SUBJECT: STAFF REVIEW OF MODIFICATIONS TO REVISION 4 OF THE BOILING-WATER REACTOR (BWR) EMERGENCY PROCEDURE GUIDELINES - LIMERICK GENERATING STATION, UNITS 1 & 2 AND PEACH BOTTOM ATOMIC POWER STATION, UNITS 2 & 3

SUBJECT: ACCEPTANCE OF PROPOSED MODIFICATIONS TO THE BOILING WATER REACTOR
(BWR) EMERGENCY PROCEDURE GUIDELINES (TAC NOS. M89489 AND M89629)

SAFETY EVALUATION REPORT
MODIFICATIONS TO THE BOILING WATER REACTOR (BWR) EMERGENCY PROCEDURE
GUIDELINES TO ADDRESS REACTOR CORE INSTABILITIES

Subject of Document: **Review of Proposed Modifications to Emergency Procedure
Guidelines for Anticipated Transients Without Scram Events**

Figure 13. Core thermal power following level increase assuming that boron does not remix.

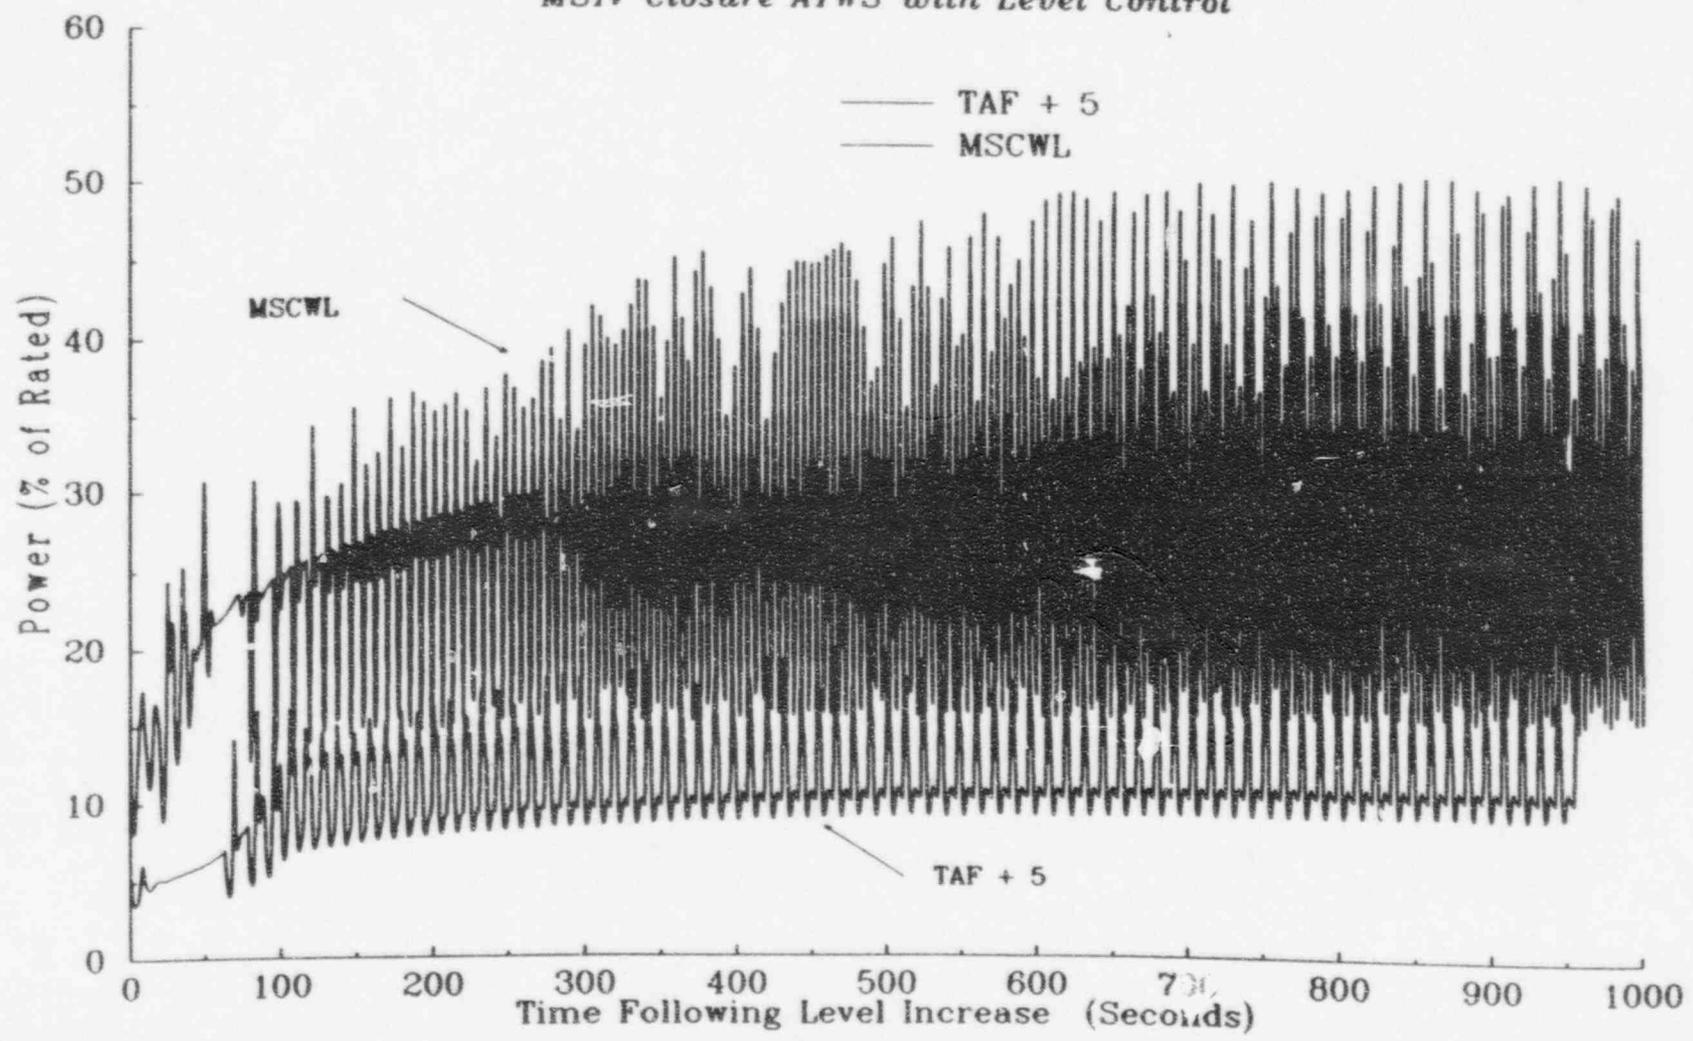
Figure 13 shows the core thermal power for the two level-control strategies if we assume that boron is not destratified when the level is raised. It can be observed from this figure that the power for the lower level strategy (MSCWL) is significantly higher than the power for the higher level strategy. This is due to the fact that the lower-level strategy has a smaller concentration of boron before the SLC injection begins to stratify; therefore, when the level is increased the flow increases and the power is higher than with the higher dissolved boron concentration of the higher-level strategy.

Figure 14. Recirculation flow following level increase assuming that boron does not remix.

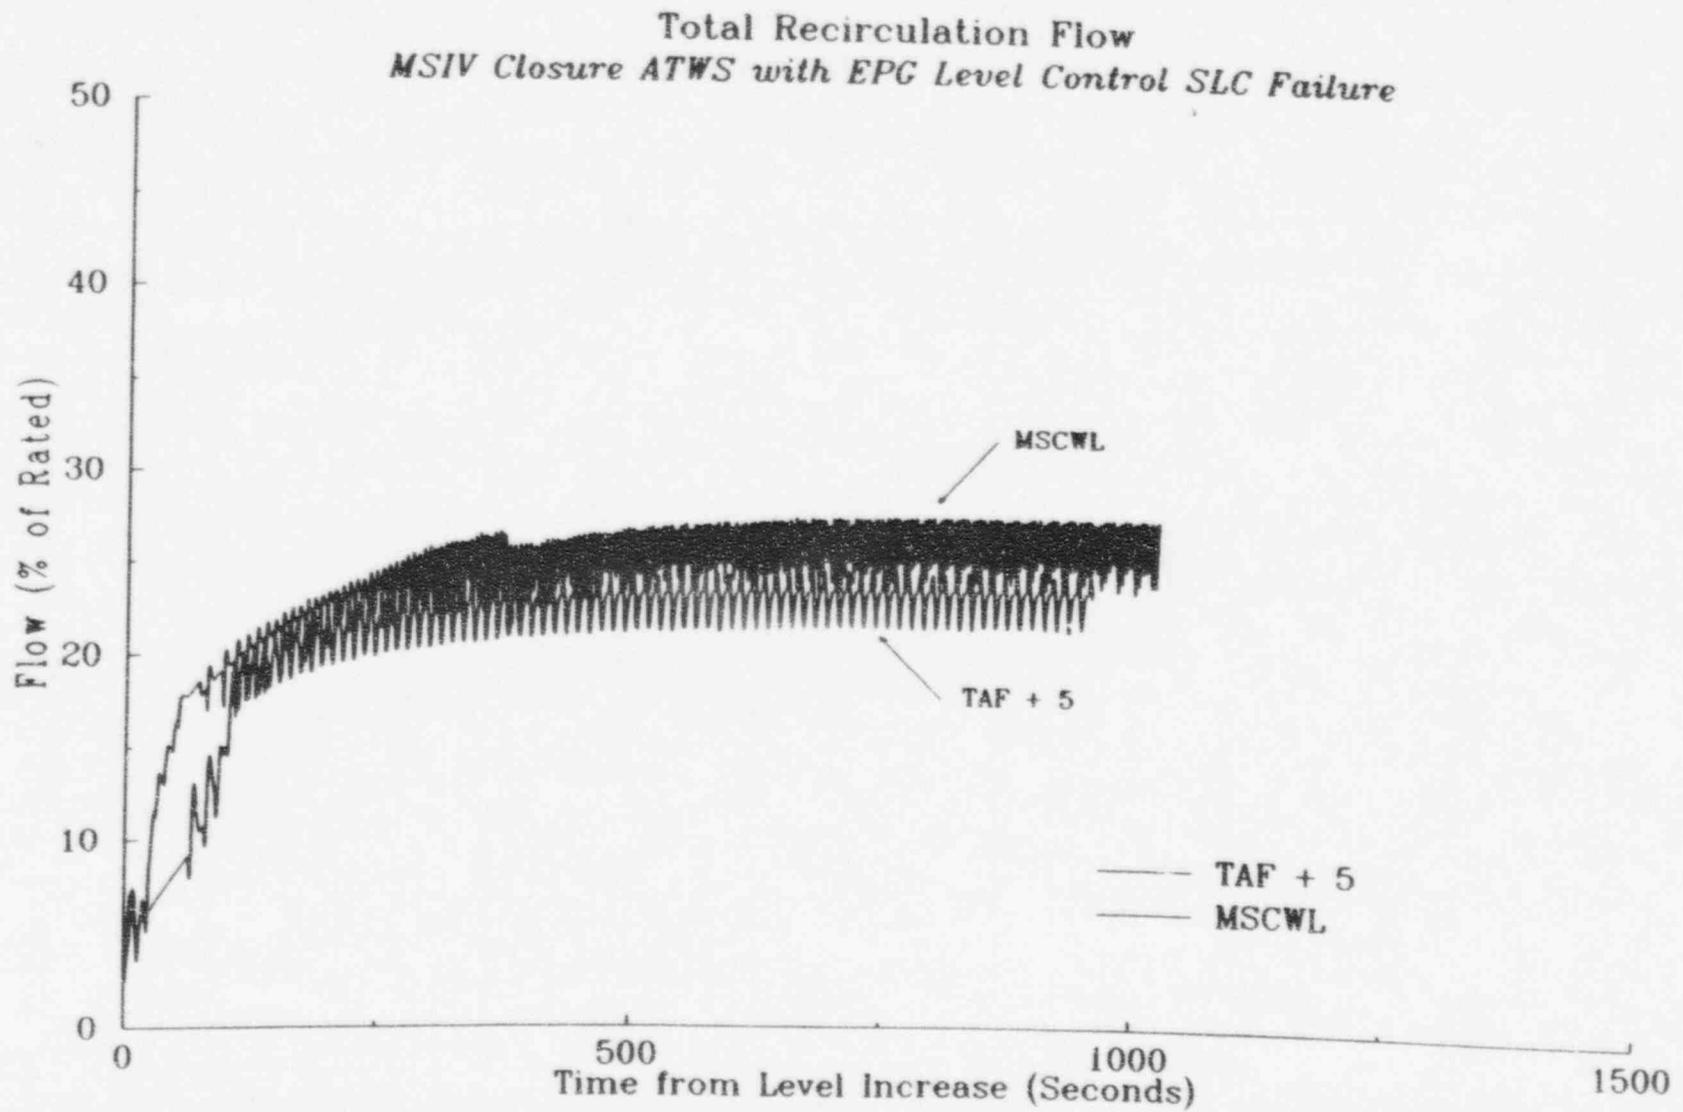
Figure 14 shows the flows reached after level increase (with failure to destratify) for both strategies. As it can be observed, both strategies reached approximately the same recirculation flow (greater than 20%) even though the power generation is quite different (see Fig. 13). This fact is not unusual and it indicates that the "natural circulation line" in the power to flow map is almost vertical, as expected. The calculations of Fig. 14 indicate that the reactor achieves a flow greater than 20% when the level is raised to remix the stratified boron; all available data indicates that stratified boron will remix at this high flow.

Figure 15. Suppression pool temperature assuming level increase without boron remixing at 1300 seconds.

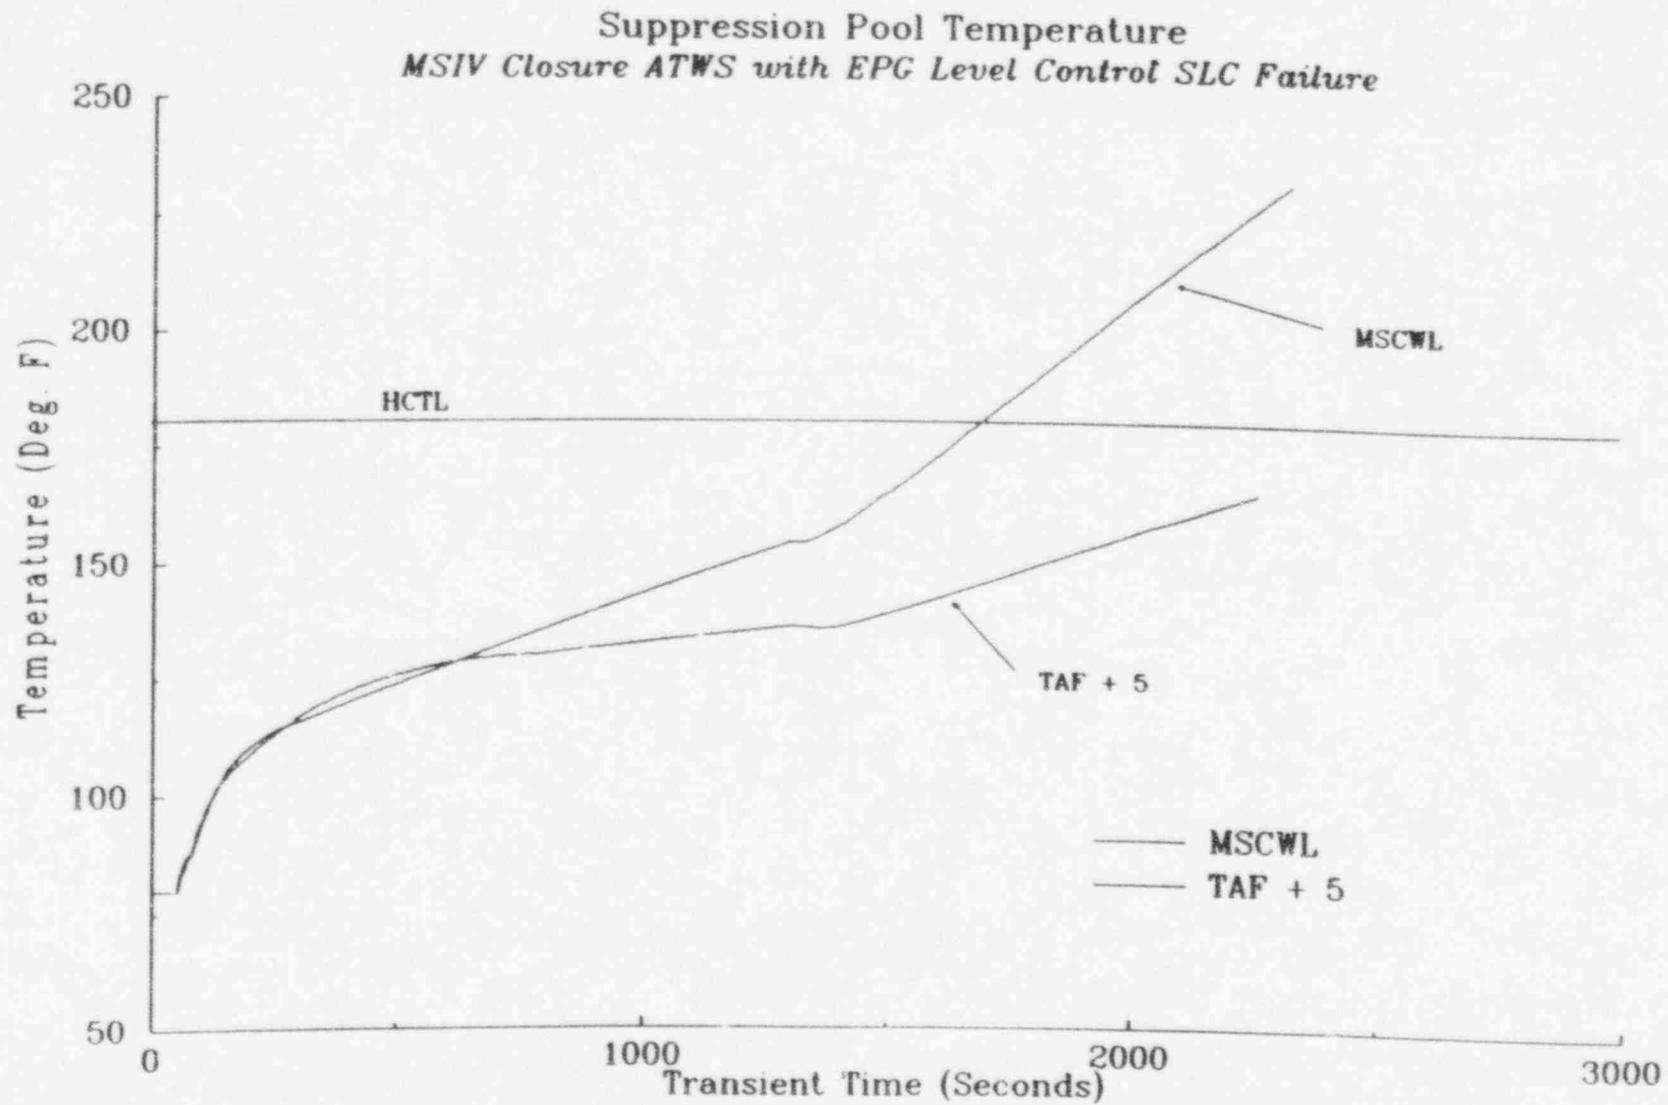
Figure 15 shows a comparison of suppression pool temperatures for the two level-control strategies when we assume that boron does not destratify and no additional boron is injected once the water level is raised. As seen in this figure, the higher-level strategy results in lower pool temperatures and more time before it reaches the HCTL (400 s for the MSCWL strategy versus 1400 s for the TAF + 5' strategy).

The calculations in Fig. 15 are extremely conservative; they not only assume that boron does not destratify, but also assume that no additional boron is injected once the level is raised. Figure 16 shows a slightly less conservative calculation, where the stratified boron is assumed not to remix, but we take credit for the additional boron that is injected by the SLC system after the level is raised and the flow increases back to 20%. When this additional boron injection is accounted for, the time available before HCTL is reached is increased significantly, and it provides more than the 10 minutes that may be required to remix the stratified boron.
